P5000A-03

Information Only Service Note

P5000A Keysight Streamline USB Vector Network Analyzer

False alarm on self-test failure on firmware revision of A.13.40.02 - DDR3 memory removal

Self-test

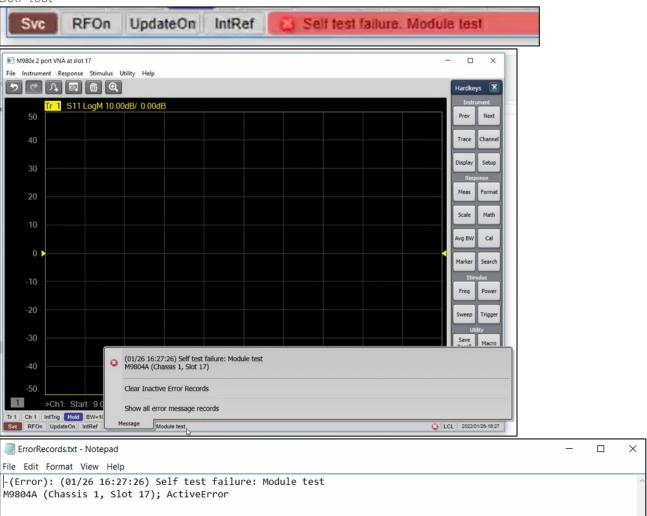
The on board DDR 3 memory in VNA is not in use since its release. With the removal of DDR 3 memory IC on newer P500xA VNA, right after firmware is launched, false alarm (self-test failure) will be reported as shown. This has no impact to VNA performance and specifications.

Similarly, firmware will report a false failure in Operator check. Shown are the error messages example on VNA firmware UI.

Since this DDR3 memory is not in use, newer firmware revision no longer consider it as the failure. Keysight recommends keeping VNA firmware up-to-date whenever it is possible.

For users with firmware revision of A.13.40.02, Update firmware to revision A.13.70.02 or newer to resolve this false alarm on self-test.
